Re: **PE 1137 WINDHAM SOLAR FACILITY – 2<sup>nd</sup> Amendment Interrogatories Submittal**

Petition No. 1137  
Windham Solar LLC- Lebanon - Franklin, Connecticut

Second Amendment Interrogatories  
July 26, 2018

## CONCRETE WASHOUT AREA

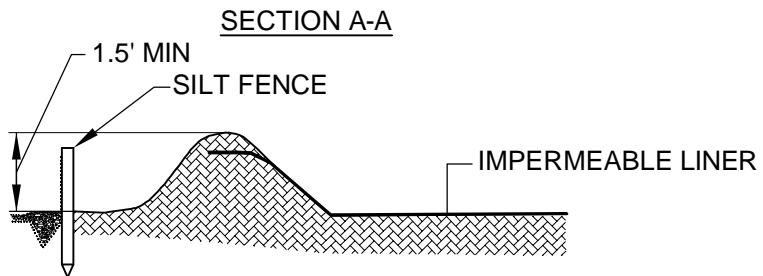
4. The Petition Amendment narrative states ballasts may be cast on-site. Indicate the location of the ballast mold area and concrete wash out station. Provide a design detail of the concrete wash out station.  
*Ballasts will be cast on site in one of the methods mentioned in the response to question #3. Attached as Exhibit A is the concrete wash out detail will be added to the plans. The projects SWCPC also addresses additional measures for Concrete Washout in section 11.4.*

CONCRETE WASHOUT AREAS WILL HAVE AN IMPERMEABLE LINER TO PREVENT CONCRETE WASHOUT WATER FROM INFILTRATING/CONTACTING WITH SOIL. IMPERMEABLE LINER INCLUDES 10 MIL POLYLINER OR COMPACTED CLAY LINER. WASHOUT SYSTEMS CAN BE USED AS ALTERNATE WASHOUT AREAS.

SITE PLAN

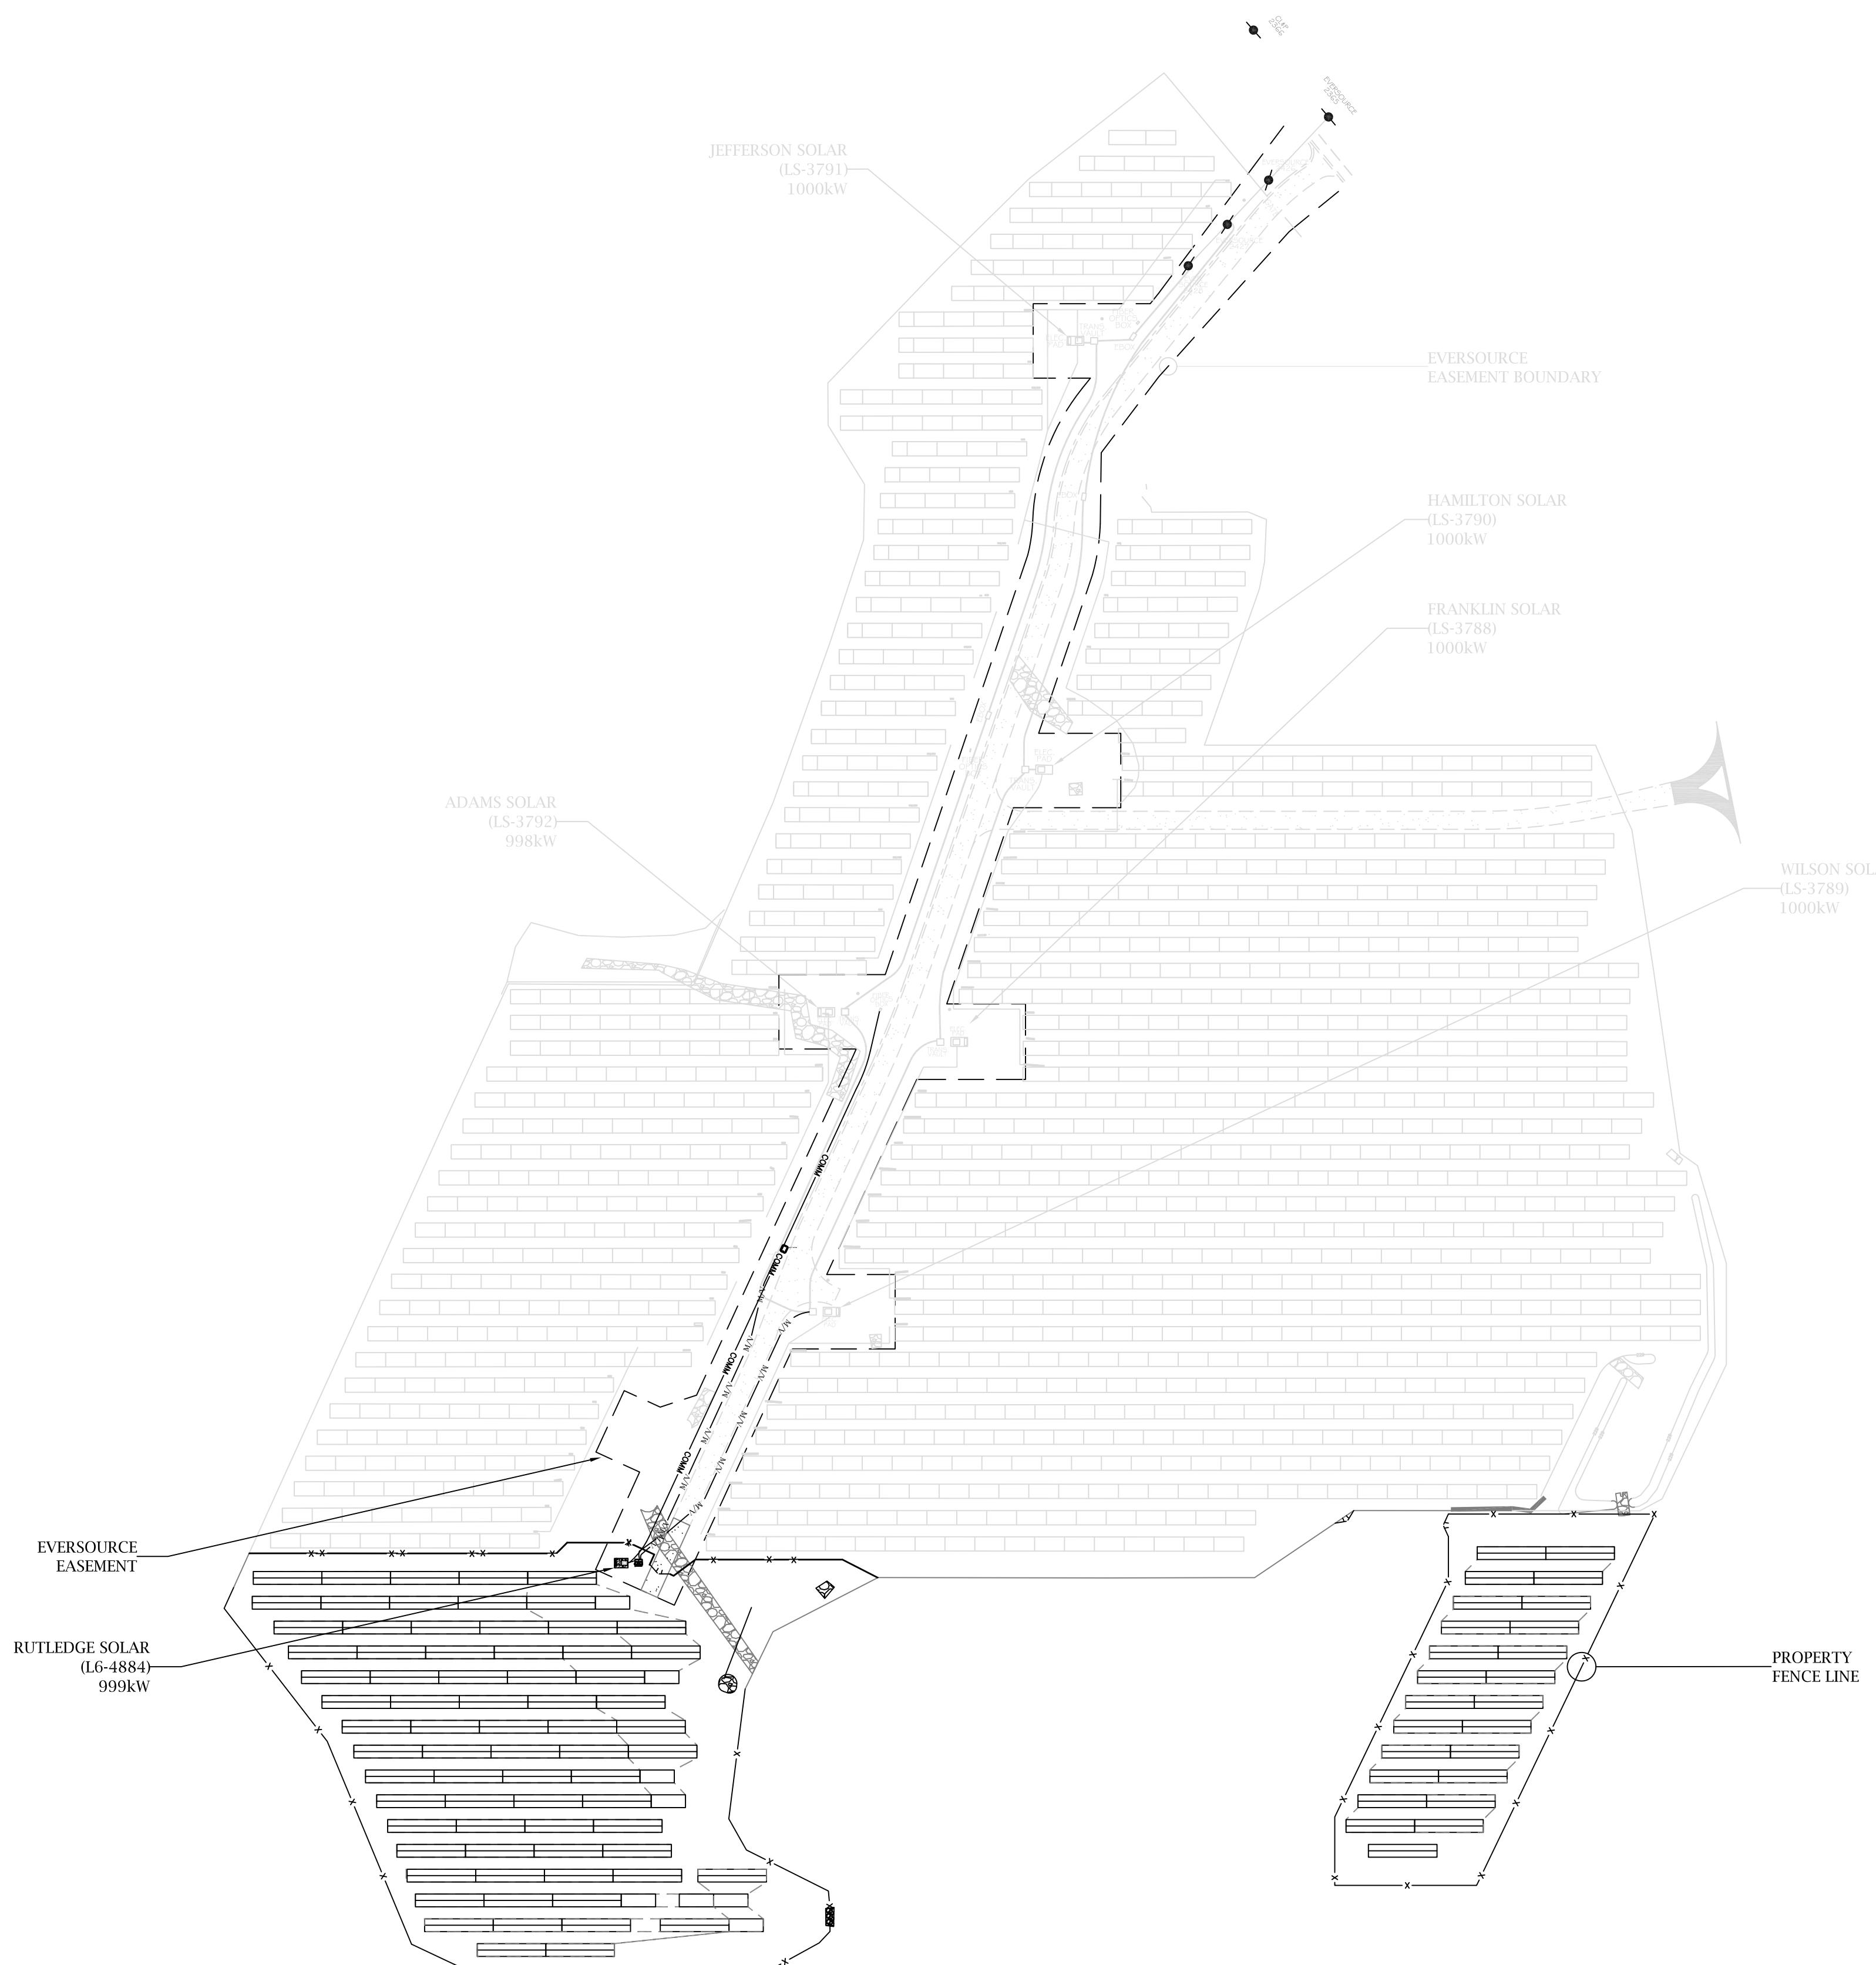
12. No new transformer/switchgear pads are shown on the Phase 2 site plans - would a modification of the existing transformer/switchgear equipment be required to accommodate the 1 MW expansion?

The transformer /switchgear pad has been identified in the AC loop drawings, not the civil construction drawings. Plans and details for the electrical system including the concrete pads have been attached as Exhibit C.
